**SUBJECT: Final Remedial Design Work Plan and Design Report for SEAD-16 and SEAD-17 at Seneca Army Depot Activity; Contract FA8903-04-D-8675, Delivery Order 0031, CDRL A004 and A007**

**FINAL  
REMEDIAL DESIGN WORK PLAN AND DESIGN REPORT  
FOR THE ABANDONED DEACTIVATION FURNACE (SEAD-16)  
AND THE ACTIVE DEACTIVATION FURNACE (SEAD-17)  
SENECA ARMY DEPOT ACTIVITY**

Appendix C: Response to Comments

**FIGURE 1-1**  
**SEAD-16 LOCATION**  
**OF HISTORICAL SAMPLES**

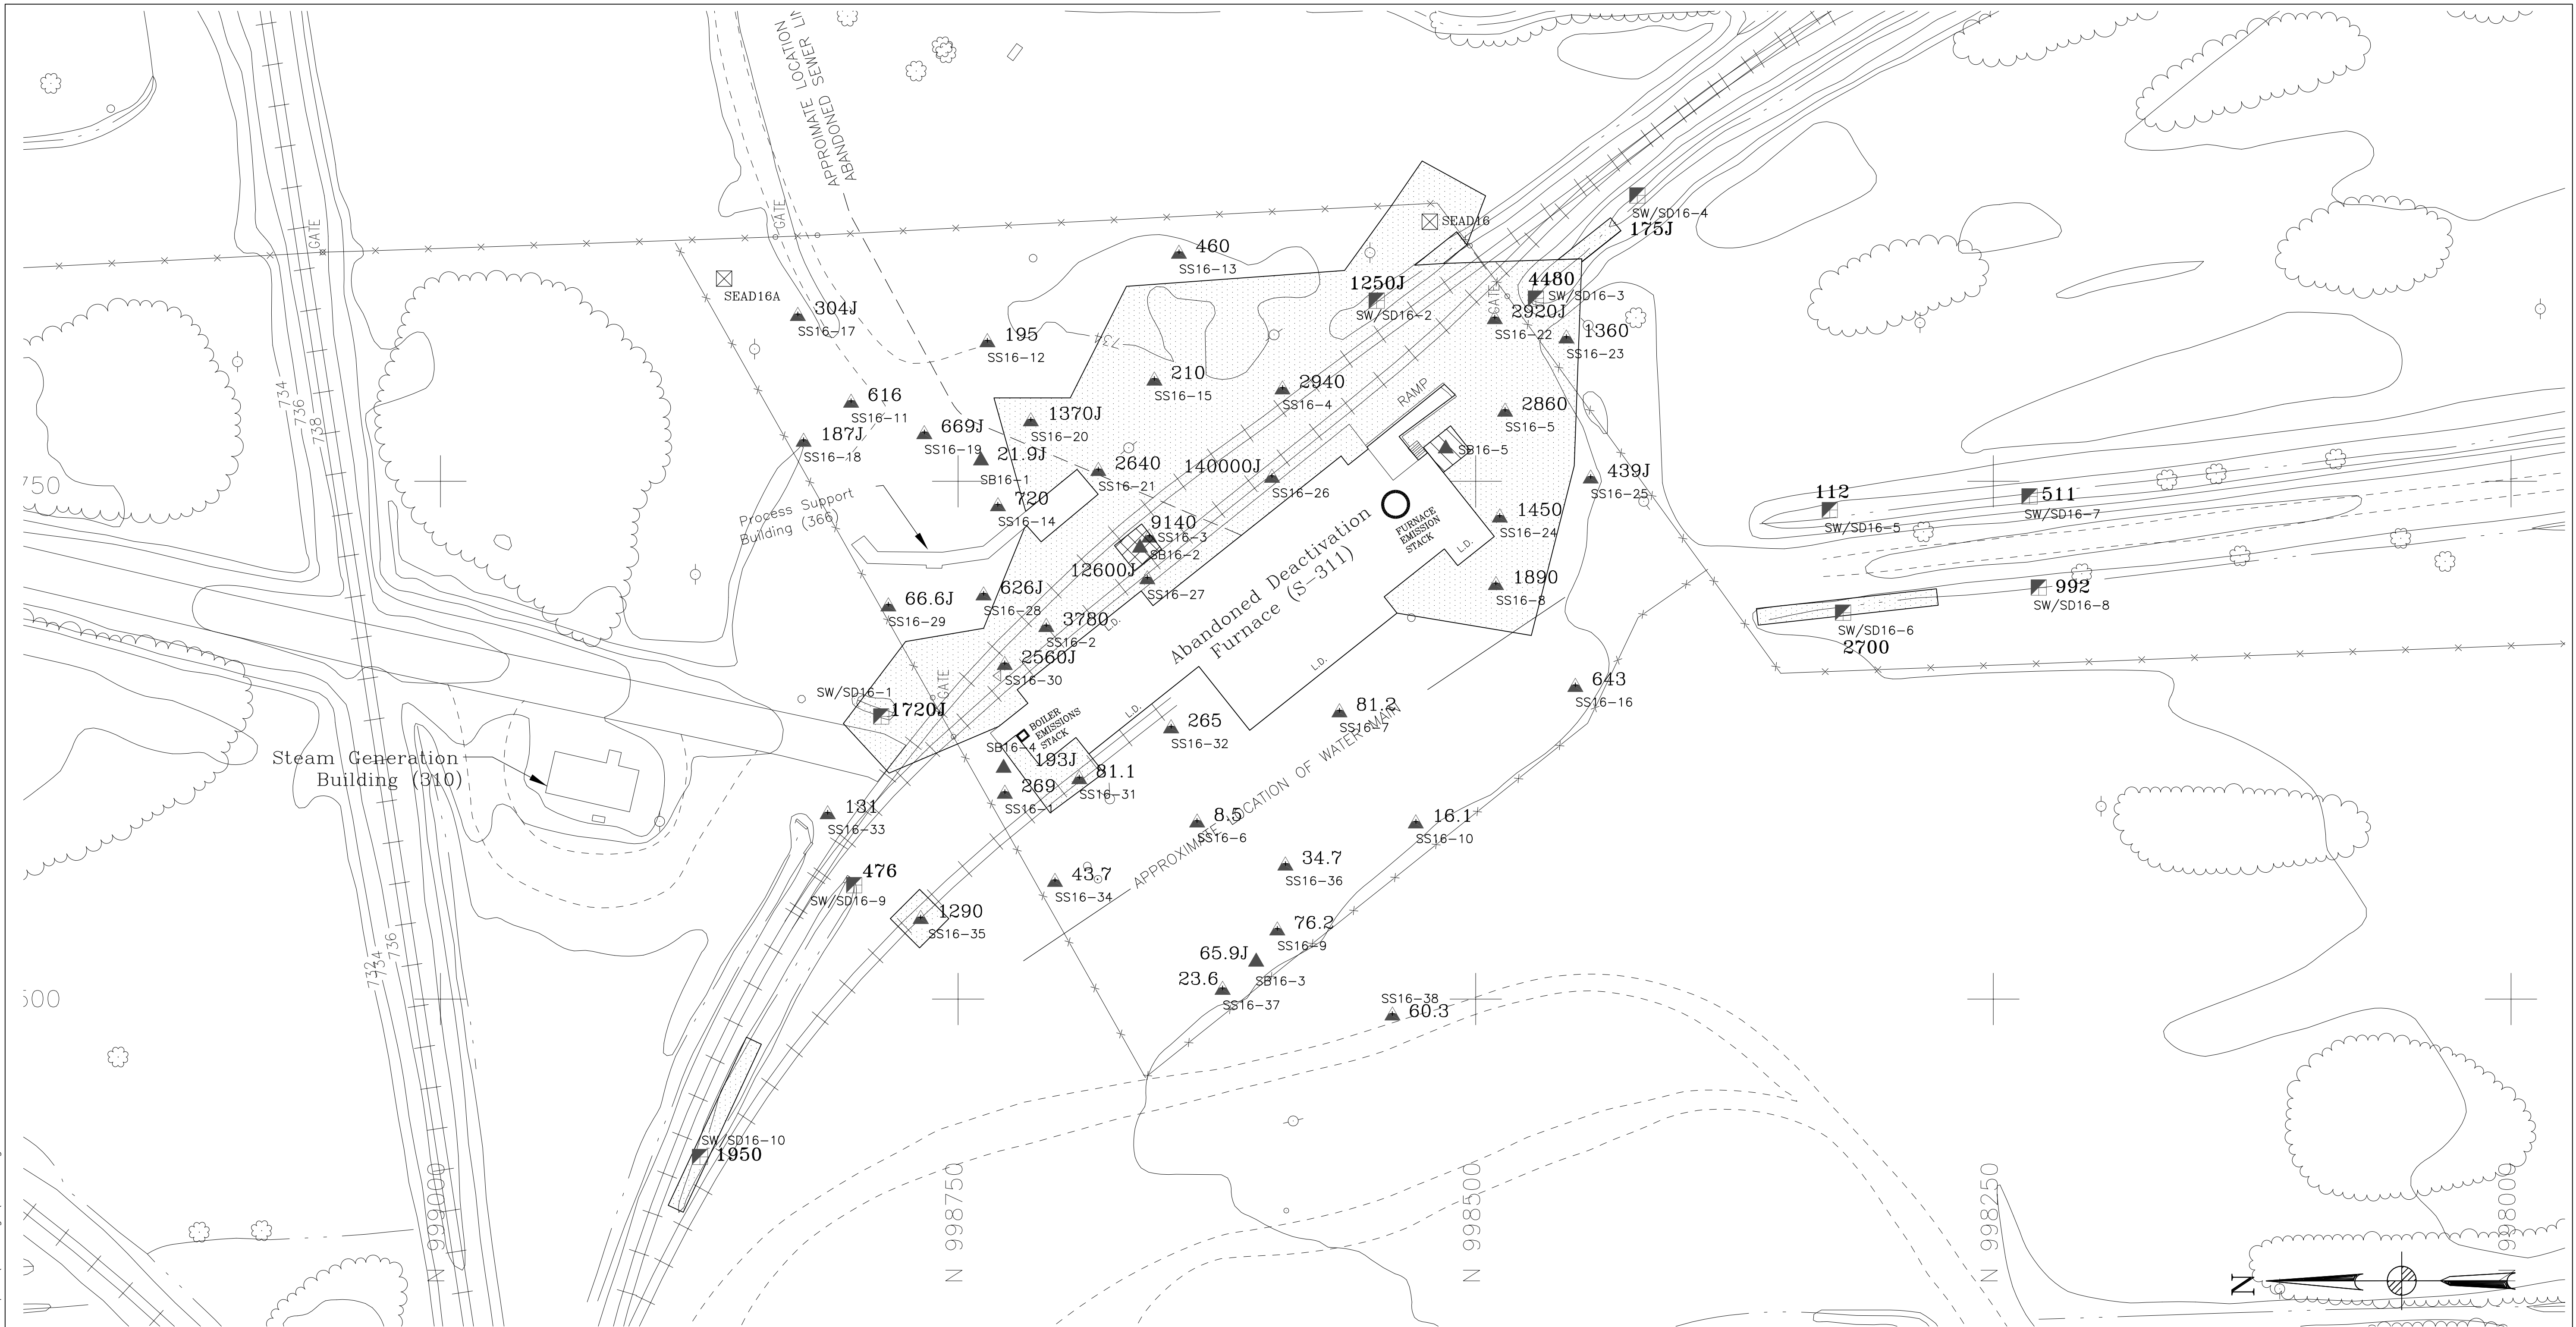
**Comment 9:** Several samples shown on Figure 1-1 are not shown in the same locations on Figure 4-1. For example, SS16-2, SS16-3 and SS16-5 are shown at different locations on the figures. Given that these sampling locations are used to identify key excavation features, it is unclear why they are not in the same locations spatially with respect to the fixed site features such as limits of excavation. Revise the two figures to correctly locate all the sample locations.

**Response 9:** It is believed that the reviewer is referring to subsurface soil samples SB16-2, SB16-3 and SB16-5. These sample locations are shown on Figure 4-1, but are not shown on Figure 1-1. In addition, only results outside of the excavation are shown on Figure 4-1. To avoid confusion, their location has been added to Figure 1-1 and clarification of the sample location labels has been added. Figures 4-1 and 4-2 have been updated as well. Excavations in the vicinity of SB16-2 and SB16-3 will be to a depth of two and three feet, respectively.

**FIGURE 4-1**  
**SEAD-16 CONFIRMATORY**  
**SAMPLING GRID AND LOCATIONS**

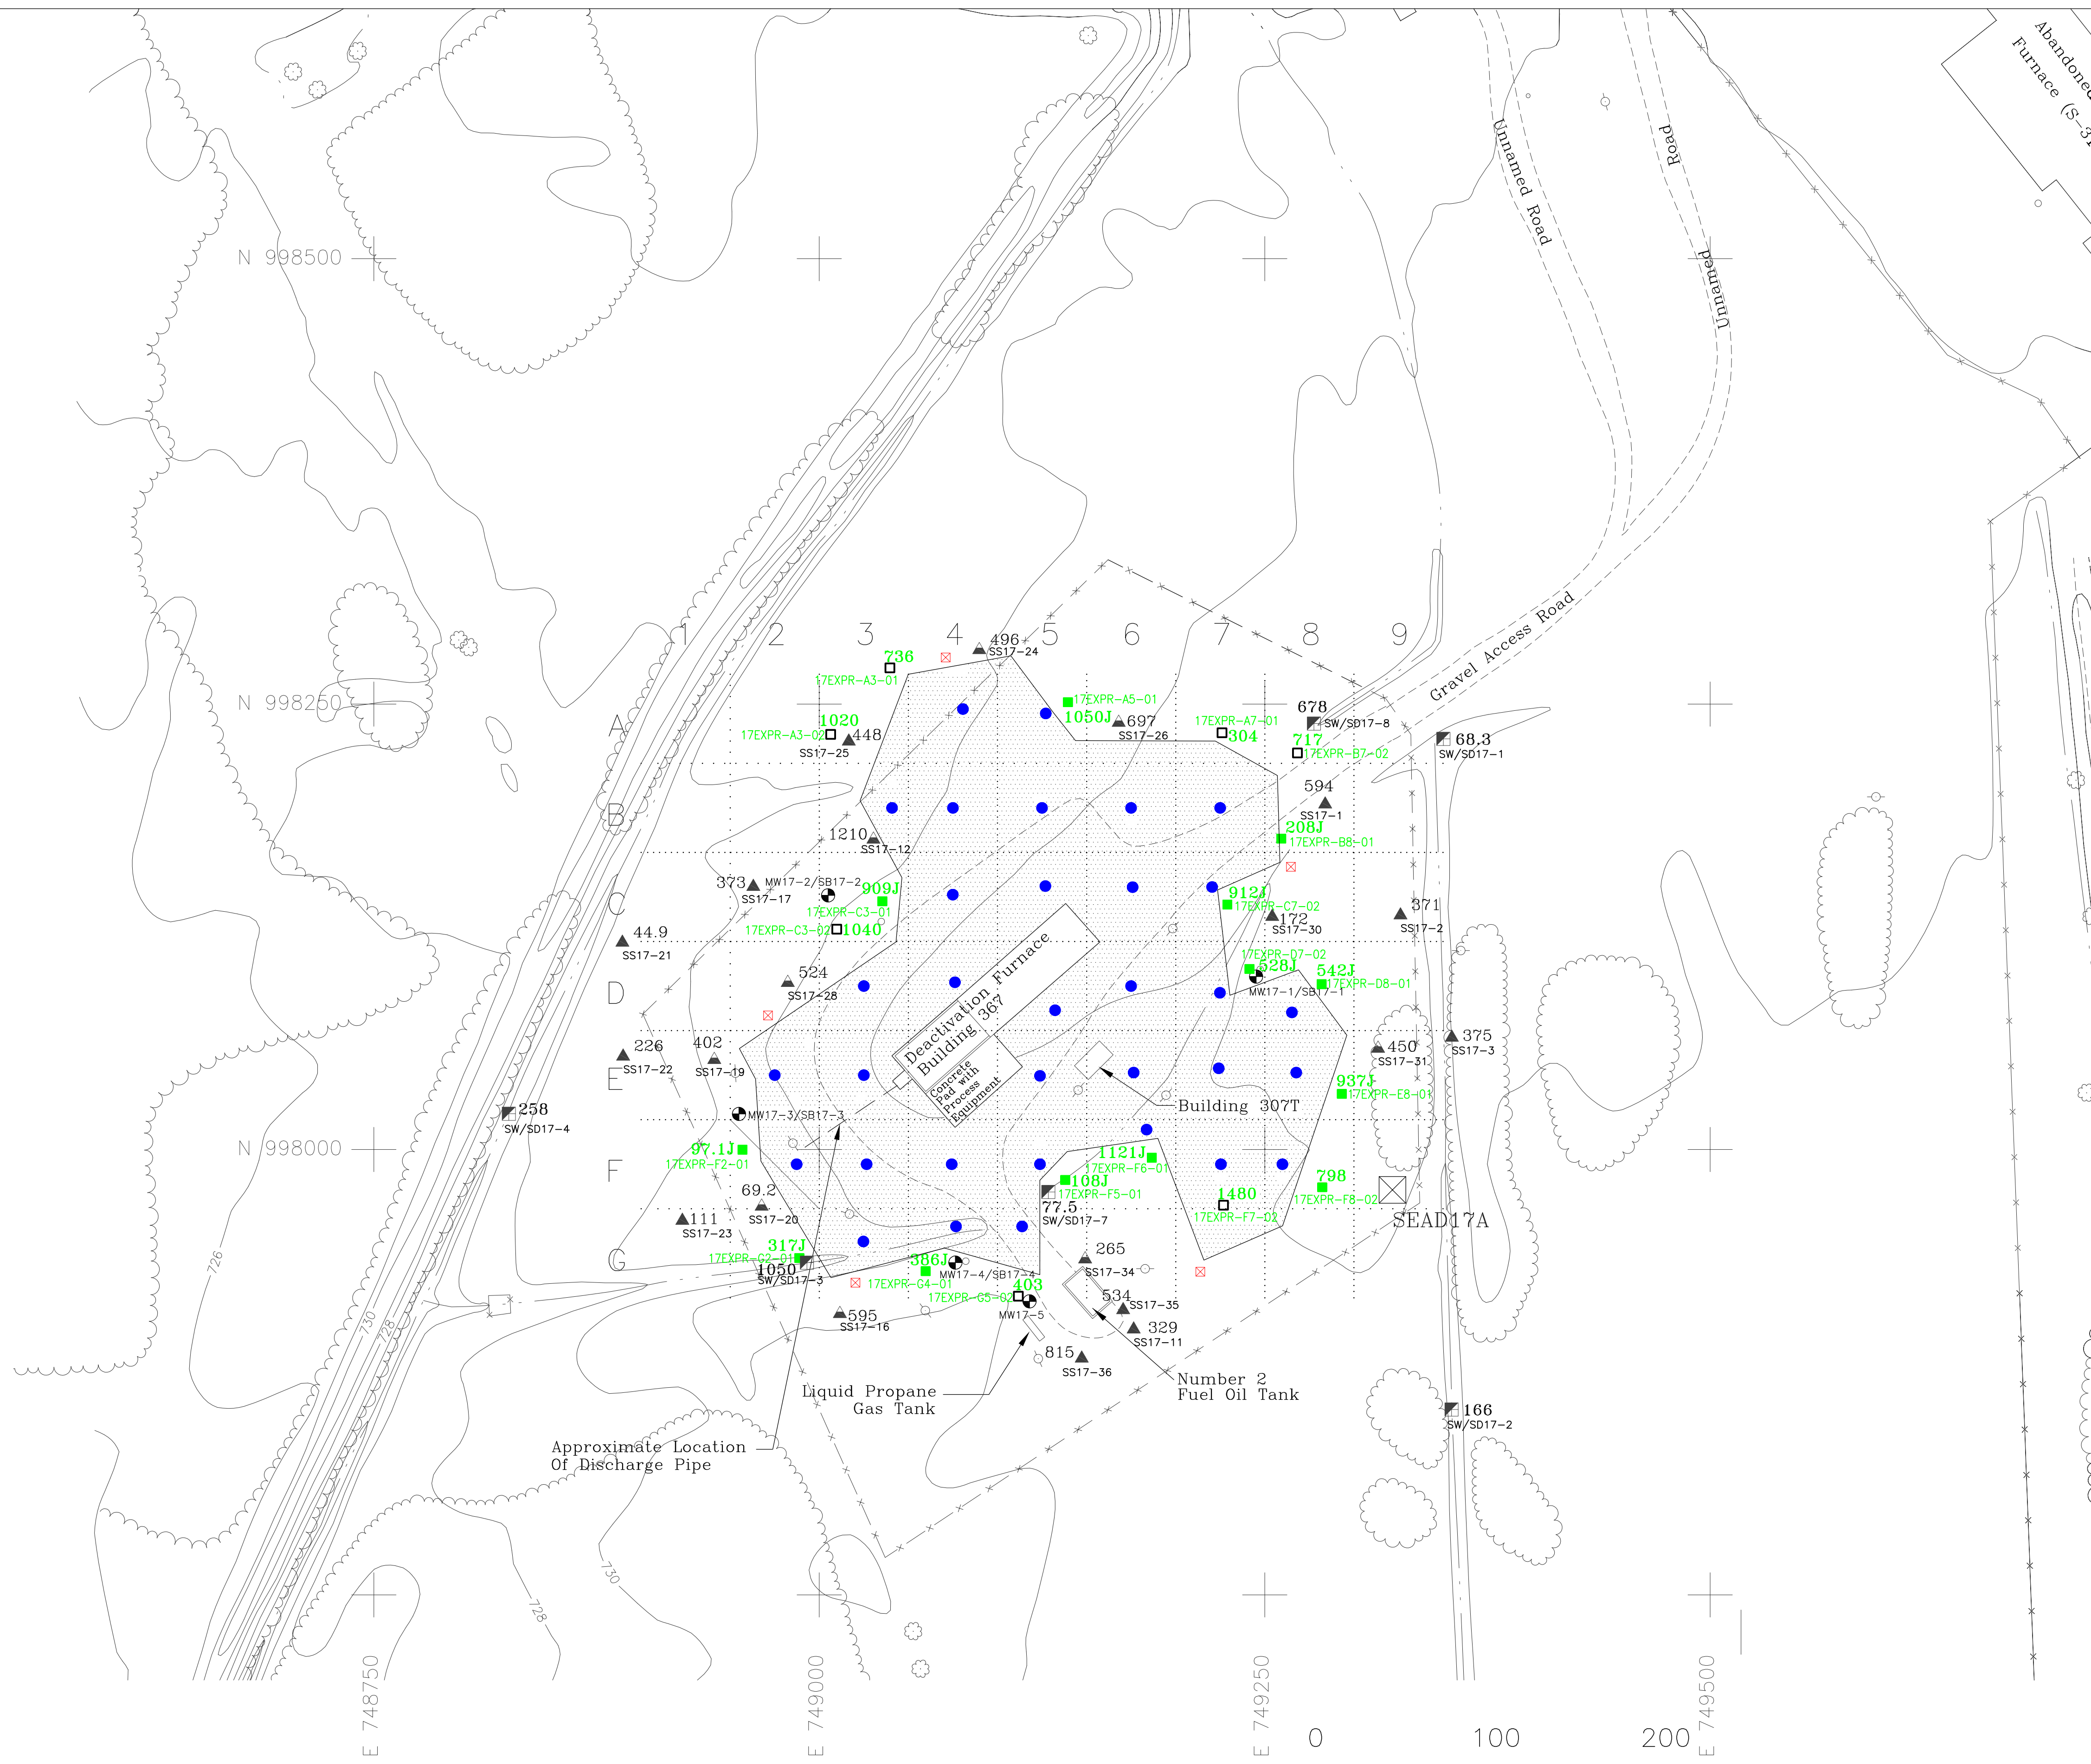
**Comment 10:** Figure 4-1 does not indicate that the sample collected in support of Grids G4 and G5 will also need to be sampled for polycyclic aromatic hydrocarbons (PAHs). Revise Figure 4-1 to clearly indicate that samples collected from Grids G4 and G5 will need to also be analyzed for PAHs.

- It is unclear how 20 perimeter samples were identified for the SEAD-16 Main Excavation Area. Revise the table to include a footnote explaining how this number was derived, as it does not appear to be reflective of Figure 4-1.

**Comment 1: Section 4.3.1.1: Sample Collection, Page 4-5.** The second sentence in the first full paragraph on this page is incomplete. Revise the Report to clearly indicate how the ends of the ditches will be sampled. Additionally, the last sentence in this paragraph indicates that 11 confirmation samples will be collected from the floor of the ditches, but it appears from Figure 4-1 that the 11 samples include the ditch perimeter sampling. Revise the statement in this sentence to reflect the locations depicted in Figure 4-1.

**Response 10:** A note has been added to Figure 4-1 to convey that samples collected from grids G4 and G5 will include analysis of PAHs.

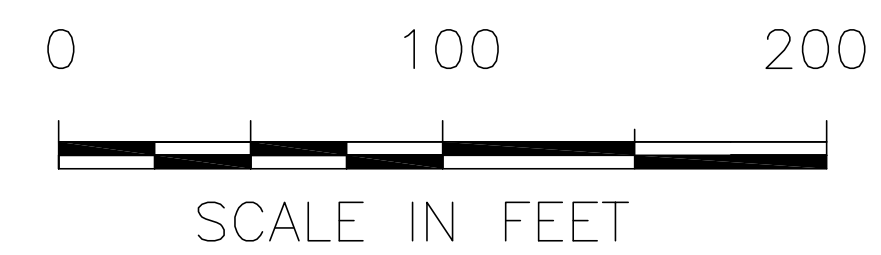
- The number of floor samples for SEAD-16 Main Excavation and SEAD-17 Soil Excavation is incorrect when compared to the sample locations shown on Figures 4-1 and 4-2, respectively. There are 21 floor samples shown in the SEAD-16 Main Excavation area on Figure 4-1, and 20 floor samples shown for the SEAD-17 Soil Excavation on Figure 4-2. Revise Table 4-1 to accurately reflect the number of sample locations shown on the corresponding figures showing SEAD site limits of excavation.

- The table indicates that 23 floor samples will be collected from SEAD-16. Figure 4-1 shows 24 floor confirmation samples. Revise the table to indicate that 24 floor confirmation samples will be collected.
- Figure 4-1 shows five additional perimeter samples for the SEAD-16 Main Excavation. Table 4-1 does not indicate that any additional perimeter samples will be collected for SEAD-16 Main Excavation. Revise the table to include the five perimeter samples for SEAD-16 Main Excavation.
- The number of additional perimeter samples for SEAD-17 according to Figure 4-2 is five samples. Table 4-1b does not include any post-excavation perimeter samples for SEAD-17. Revise Table 4-1b to accurately reflect the five additional perimeters sample locations shown on Figure 4-2.

In general, Table 4-1a shows the theoretical number of samples required in order to meet the frequency specified in the plan. Figure 4-1 and 4-2 show the location of these samples. Based on the geometry of

The five additional perimeter samples for SEAD-16 and SEAD-17 have been added to Figures 4-1 and 4-2, respectively, represented by a red square with an "x". Table 4-1b has been updated to reflect the addition of these samples.
